Date: 1/8/2021
Project: University of New Mexico Hospitals - New Hospital Tower
2211 Lomas Blvd NE
Albuquerque, NM 87106

Bid Package: Phase I - Make Ready
ASI #: 04 (REVISED)

SCOPE OF WORK FOR ASI #4 IS INCLUSIVE OF ITEMS SHOWN ON THIS SHEET THAT ARE RELATED TO BLUE PHONE ONLY

Sheet Name
CG103

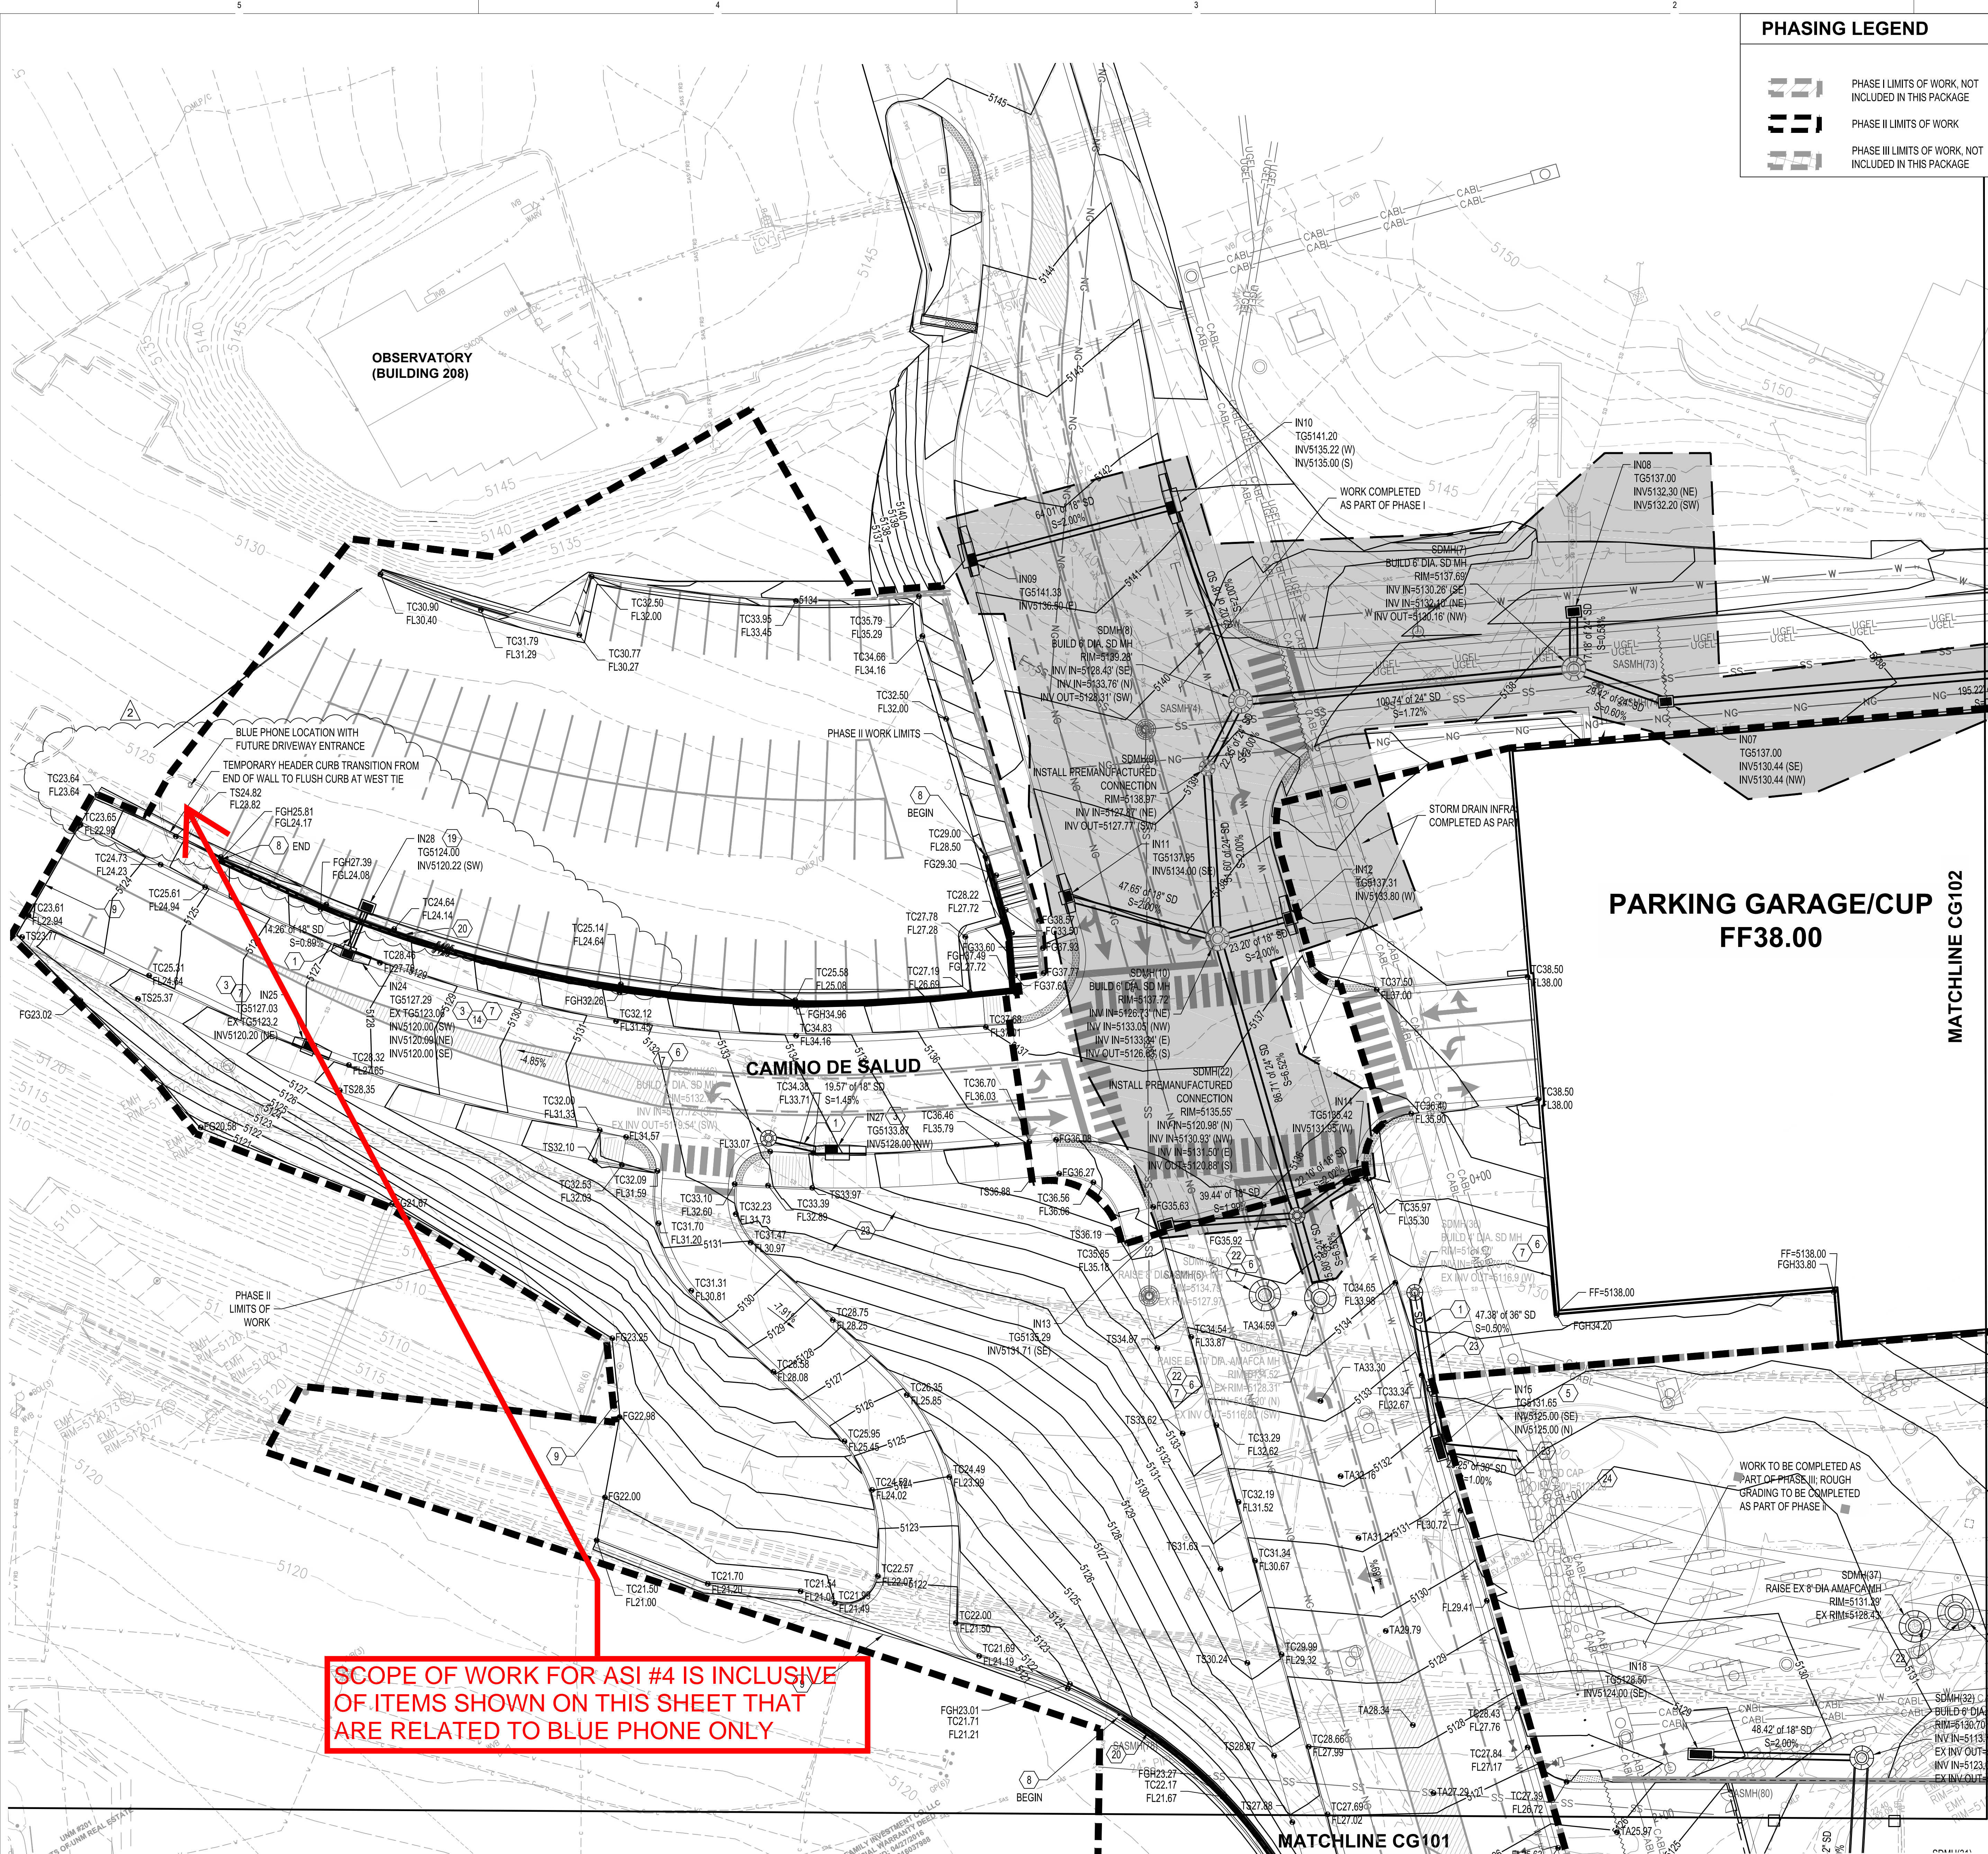
No	Doc Ref	Revision description
Civil		
1	CG103 (REVISED)	Revised grading around the Blue Phone area. See revised sheet.
2	HC103	Revised Horizontal Control around the Blue Phone area. See revised sheet.
3	N/A	CAD FILES WILL BE PROVIDED UNDER SEPARATE COVER TO BE USED FOR LOCATING BLUE PHONE.
Landscape		
1	LS102 (REVISED)	Revised plan sheet showing updated south code blue phone location.
Electrical		
1	ES-100 (REVISED)	Revised plan sheet showing updated south code blue phone location.
Technology		
1	TS-100 (REVISED)	Added blue phone re-location requirements, conduit and cable. Refer to drawing for addition information.

Sheet Number
LS102

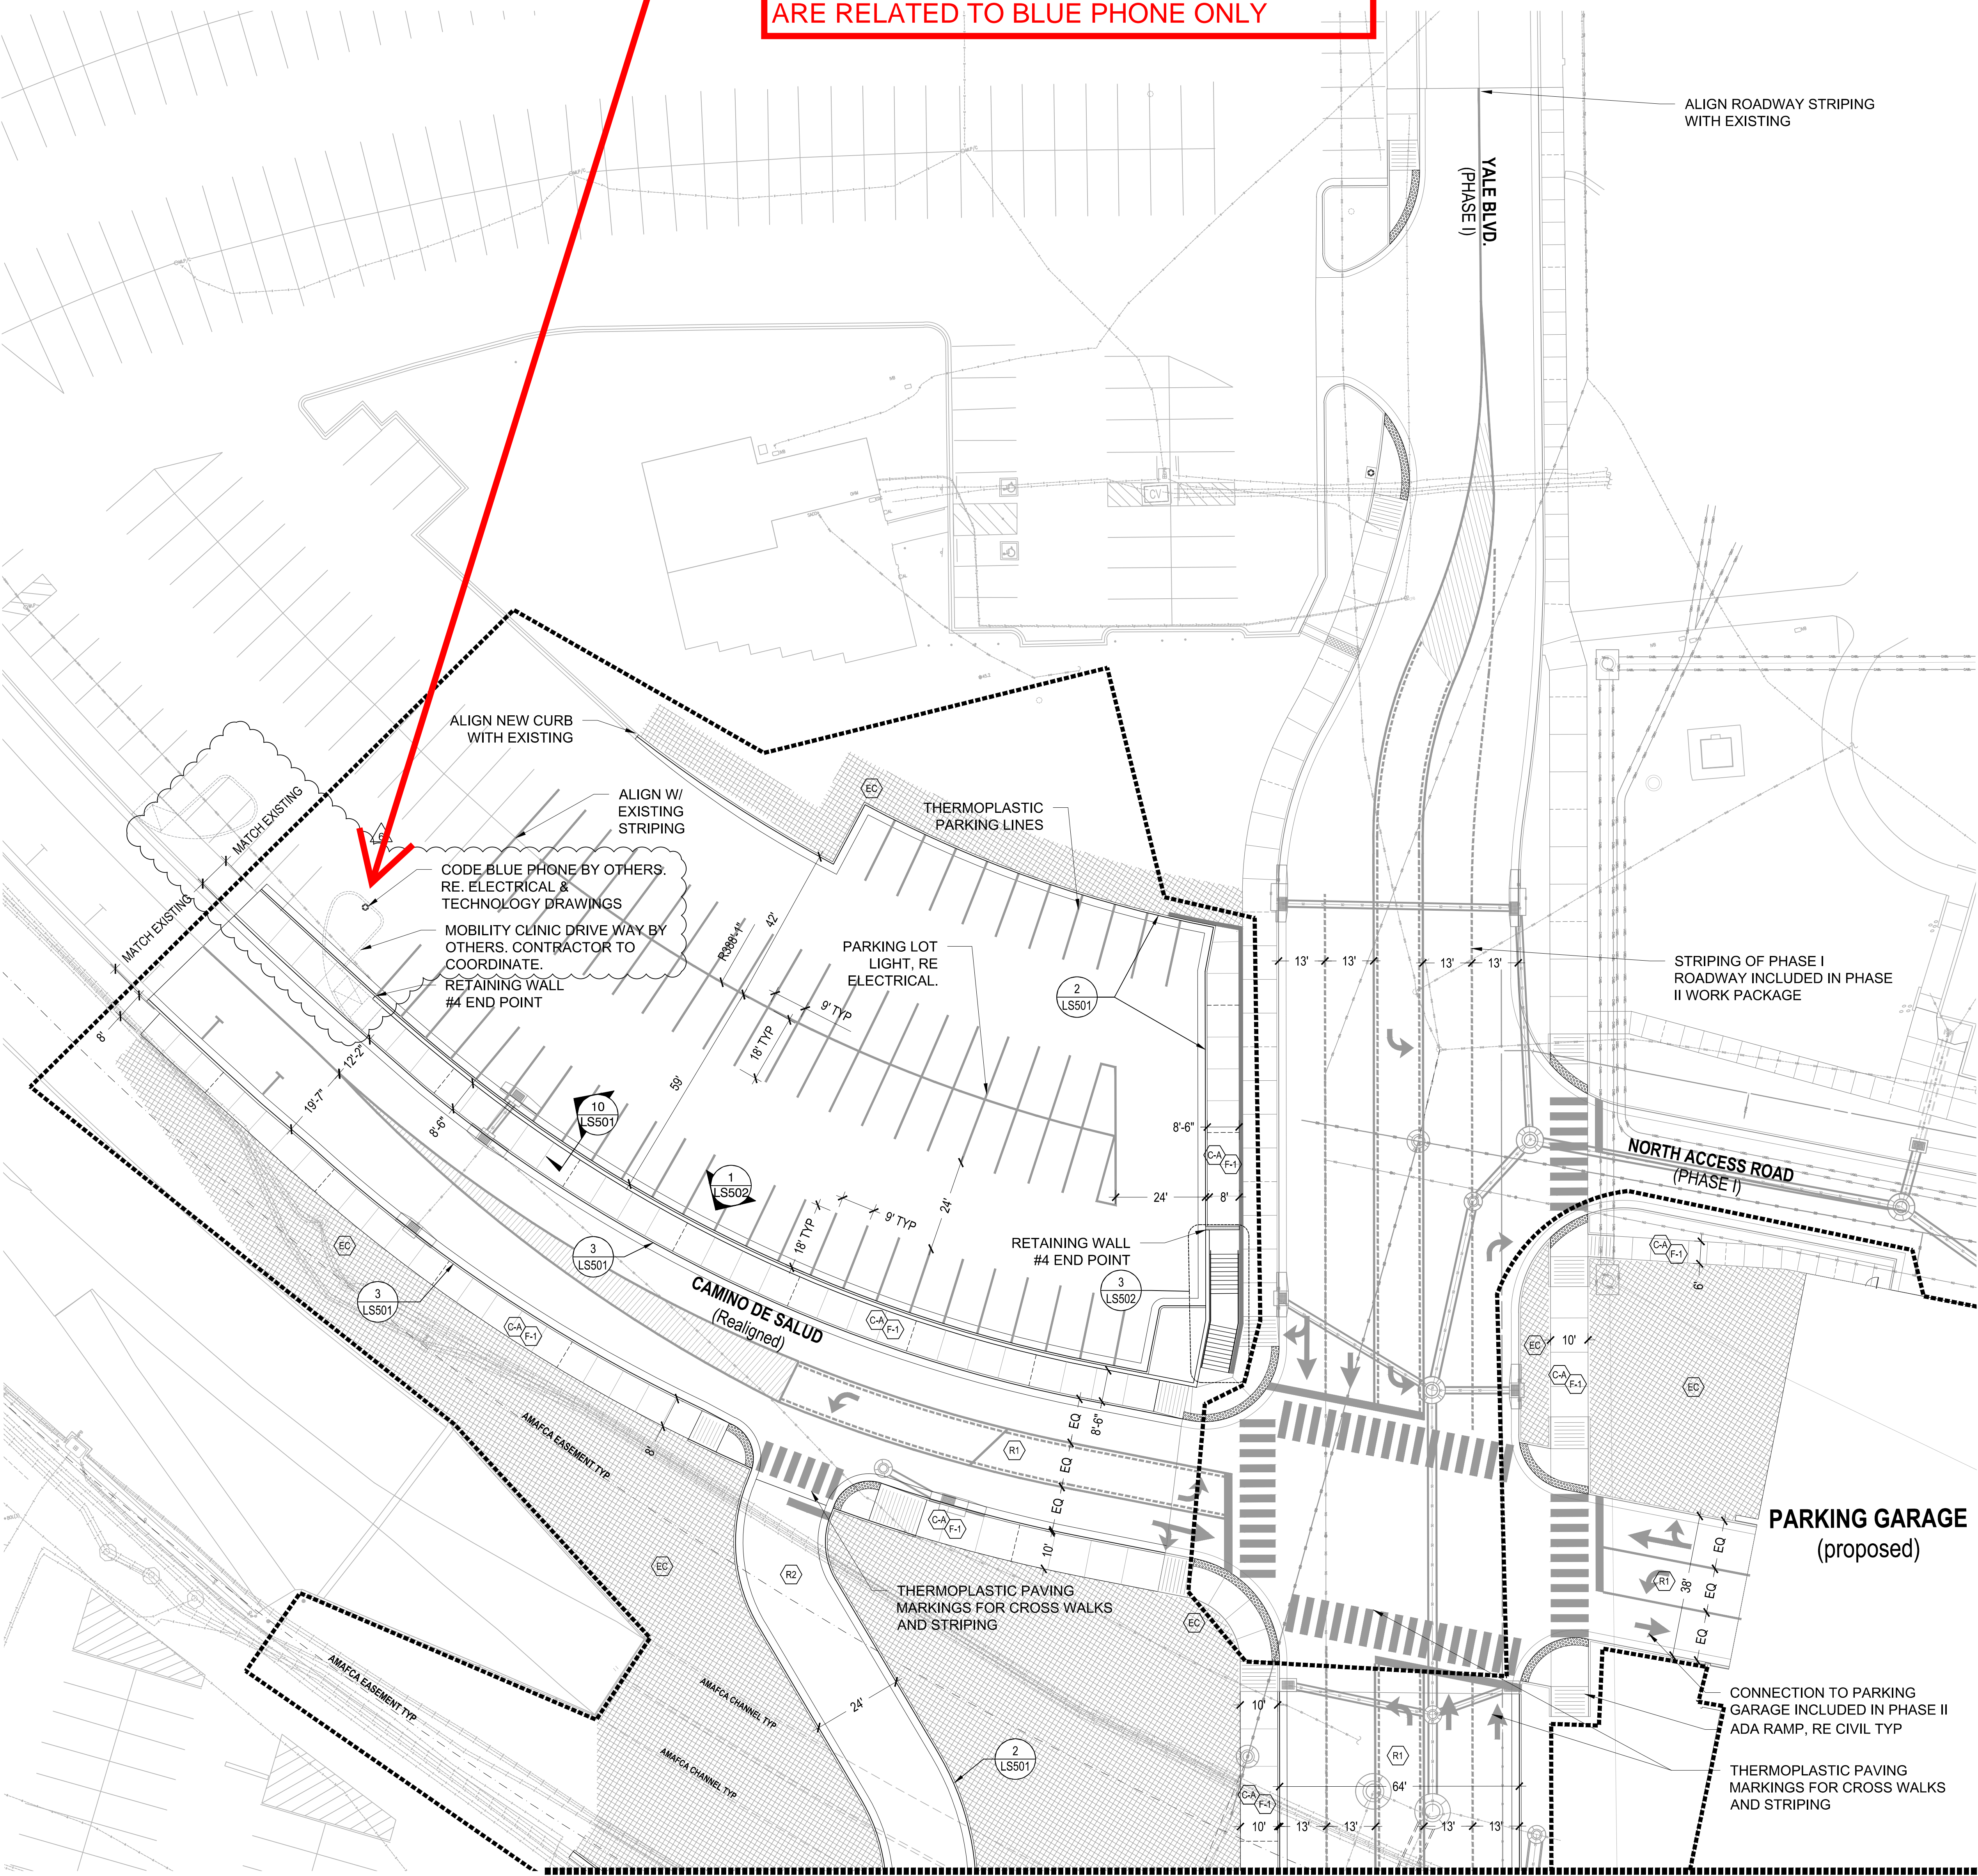
SCOPE OF WORK FOR ASI #4 IS INCLUSIVE OF ITEMS SHOWN ON THIS SHEET THAT ARE RELATED TO BLUE PHONE ONLY
